Department of Energy
Carlsbad Field Office
P. O. Box 3090
Carlsbad, New Mexico 88221
May 21, 2010

Subject: Planned Change Notice for the RH-72B Neutron Shielded Canister

NS15 & NS30 NEUTRON SHIELDED CANISTER

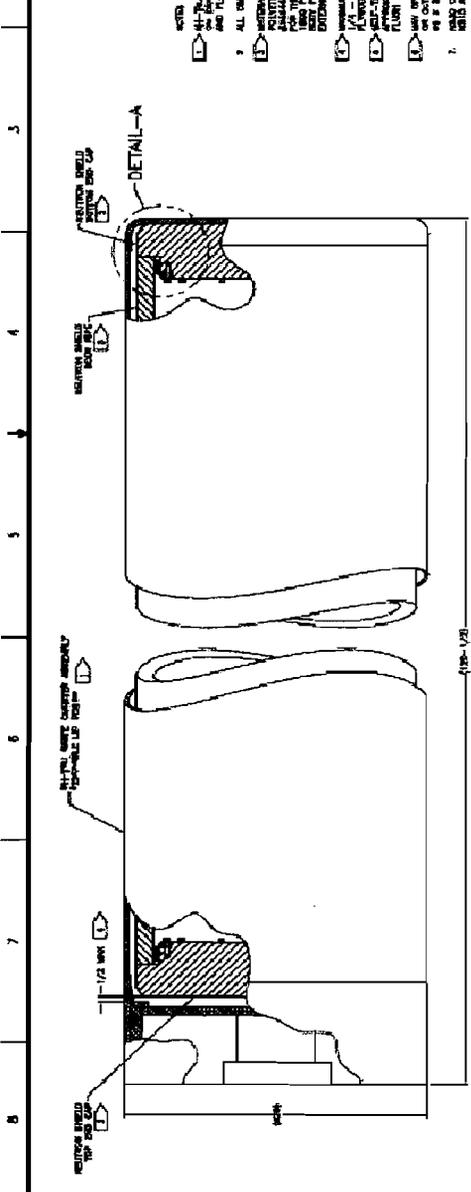
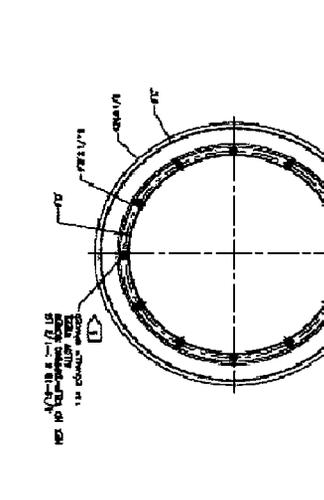
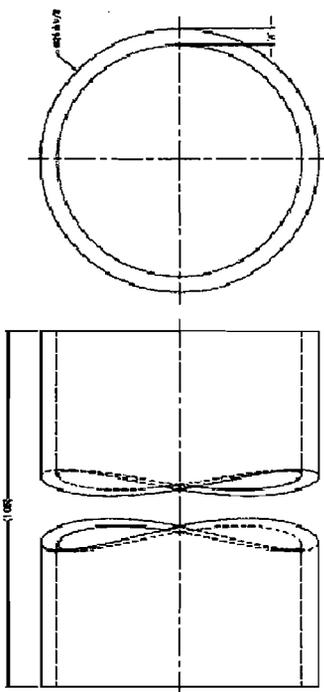
The HDPE liner and end caps provide neutron shielding for the RH-72B canister. This neutron shielded canister will have two possible configurations, NS15 or NS30, as shown in the attached drawing (X-106-503-SNP). The NS30 neutron shielded canister has a liner with a nominally 1.454 inch thickness of HDPE and HDPE top and bottom end caps are nominally 5 inches thick. This canister is designed to be direct loaded or to carry three vented 30-gallon steel drums with internal lever-lock closures, and will provide a neutron attenuation factor of about 3. The NS15 neutron shielded canister is essentially identical to the NS30 with a cylindrical liner that is nominally 3.387 inches thick and HDPE top and bottom end caps, nominally 5 inches thick. The NS15 is designed to be direct loaded or carry three vented 15-gallon steel drums with internal lever lock closures, and will provide a neutron attenuation factor of about 8.
